Title of Change:	Change the C Pak cover tape Model from CP23D to CP38 and width from 5.3mm (Milky) to be 5.4mm (Clearly) at Stars Micro
Effective date:	03 Nov 2020
Contact information:	Contact your local ON Semiconductor Sales Office or Pallop.Sathiennet@onsemi.com
Type of notification:	This Product Bulletin is for notification purposes only. ON Semiconductor will proceed with implementation of this change upon publication of this Product Bulletin.
Change Category:	Packing-cover tape change
Change Sub-Category(s):	Packing-Cover tape change

Seal vision:**CP23D-053A, 5.3 mm (OLD)**

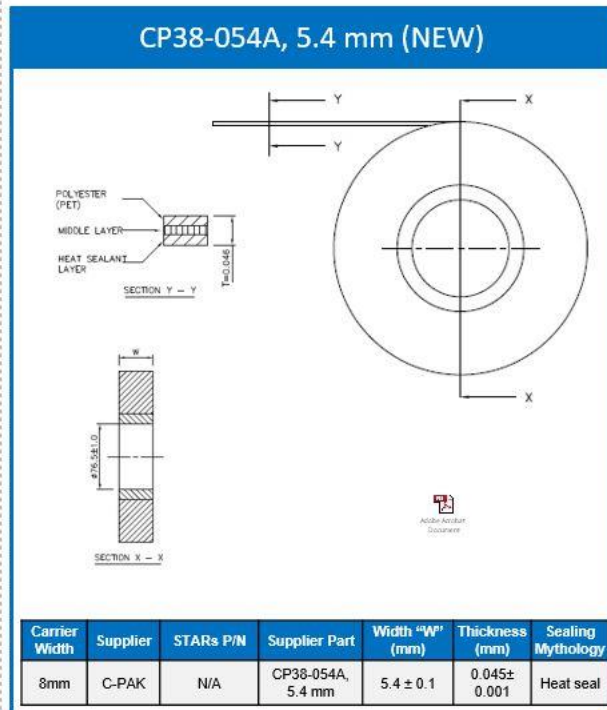
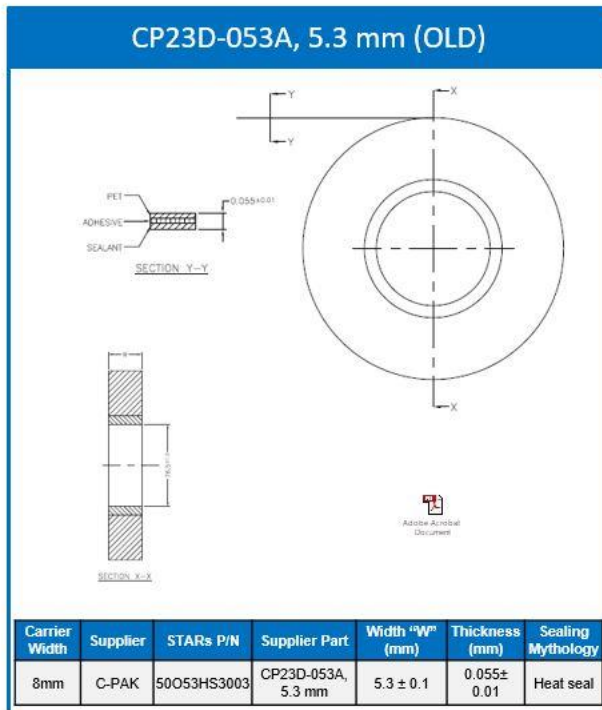
Change the C Pak cover tape Model from CP23D to CP38 and width from 5.3mm (Milky) to be 5.4mm (Clearly) at Stars Micro
 "The change will not impact form, fit, or function of product(s)"

Cover tape will be easier caused adhesive bleeding out and become the residue contamination.

**CP38-054A, 5.4 mm (NEW)**

Cover tape will not be caused adhesive bleeding out and become the residue contamination.
